Proposed alteration to roofline to :-

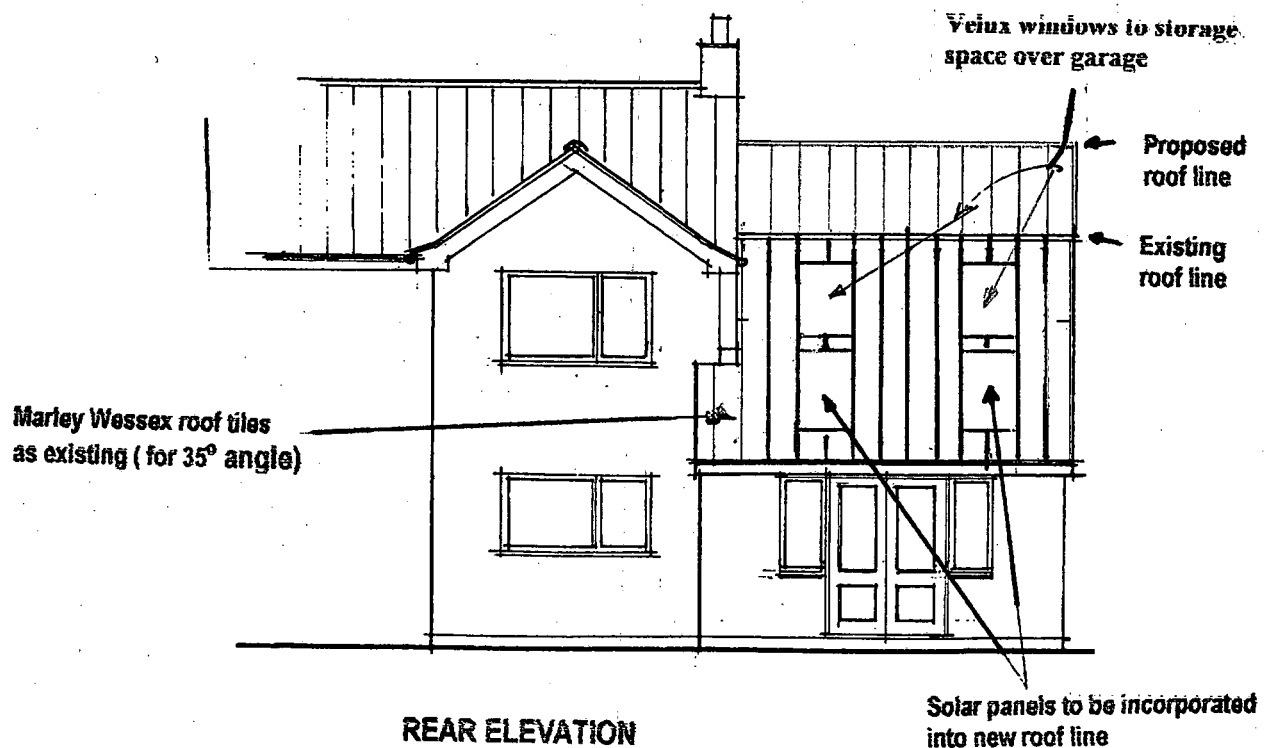
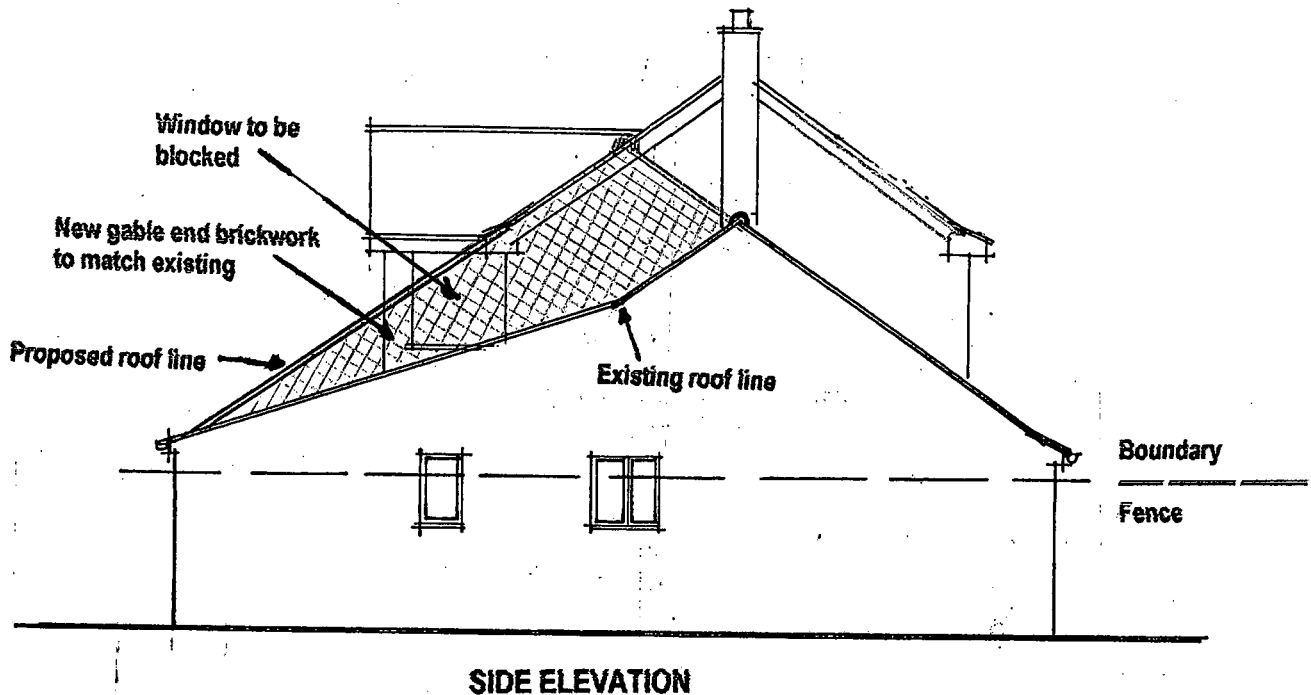
- Provide 35° angle to accommodate Solar Panels
- Provide additional storage space over garage
- Incorporate Velux Windows
- Improve visual impact of gable end by removing change in roof angle
